[Docket No. 2000–SW–60–AD]

#### Airworthiness Directives; Bell Helicopter Textron, Inc., Model 412 Helicopters

**ACTION:** Notice of proposed rulemaking (NPRM).

FIGURE 1

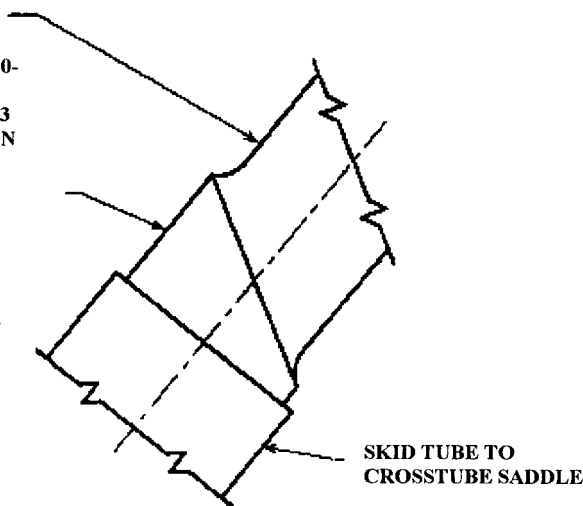
(3) Vibro-etch the P/N on the crosstube assembly adjacent to the skid tube saddle in accordance with Figure 1 for any crosstube assembly not displaying a visible P/N. Identify the crosstube assembly as P/N 412-050-011-107 FM.

(4) Vibro-etch a serial number (S/N) on the crosstube assembly below the P/N in accordance with Figure 1. The S/N must be unique for each crosstube assembly.

THE FACTORY HAS INK  
STAMPED THE SUBASSEMBLY  
AND SYNTHETIC P/N 412-050-  
044-101, -101A, OR -103 IN THIS  
GENERAL AREA.

CROSSTUBE ASSEMBLY P/N 412-050-  
045-107 HAS THE NEXT LOWER  
(SUBASSEMBLY) P/N 412-050-044-103  
VIBRO-ETCHED IN THIS LOCATION  
FROM THE FACTORY. THE S/N IS  
POSITIONED UNDER THE P/N.

VIBRO-ETCH 412-050-011-107 FM  
AND A COMPANY CONTROLLED  
S/N IN THIS AREA AS REQUIRED  
TO TRACK REMAINING HIGH AFT  
CROSSTUBE LIFE. VIBRO-  
ETCHING DEPTH SHALL NOT  
EXCEED 0.005 INCH.
